32.28 Frames (supersedes P1364 26.6.20)

Change the proposal for Item 485 as follows:

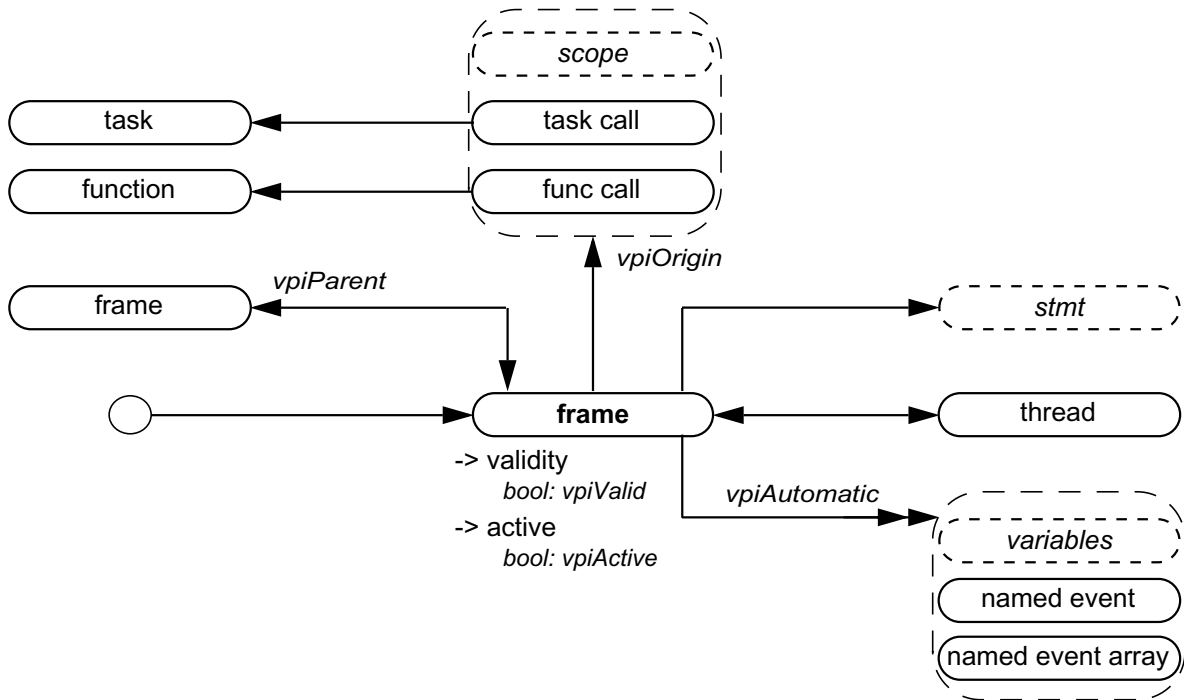
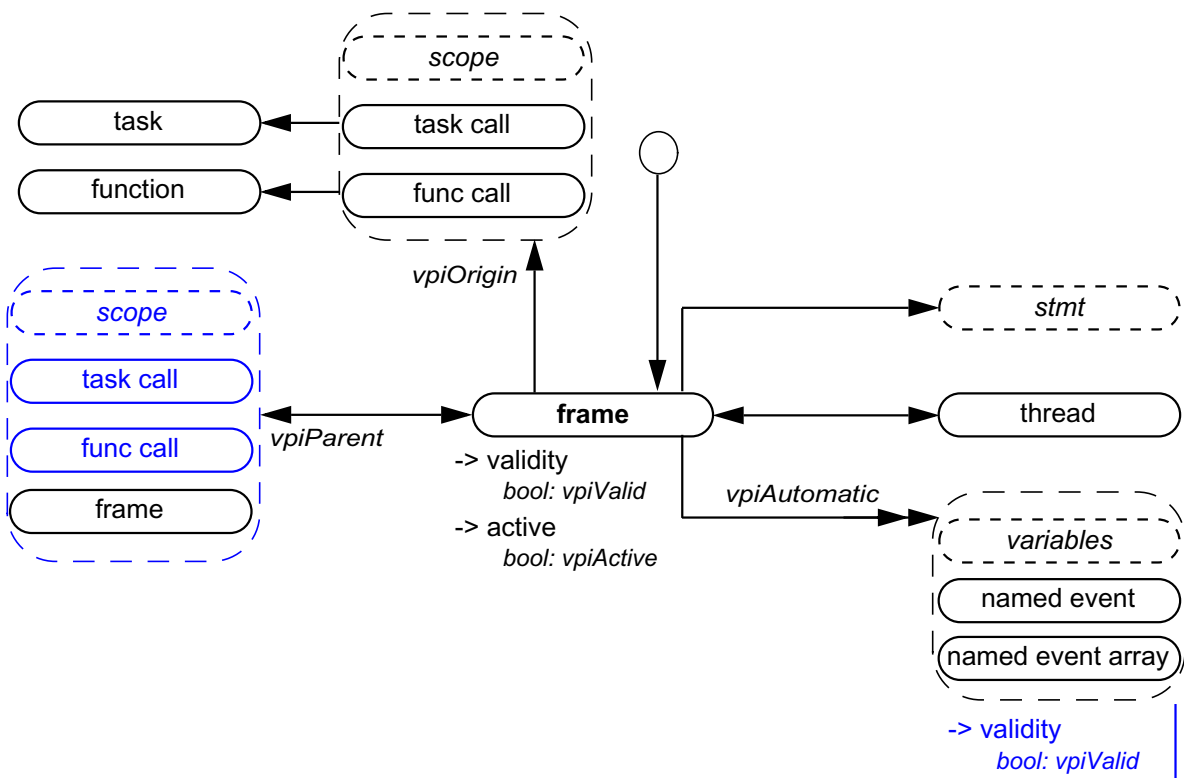
- 7) ~~The Frame object model is not backwards compatible with IEEE 1364-2005.~~
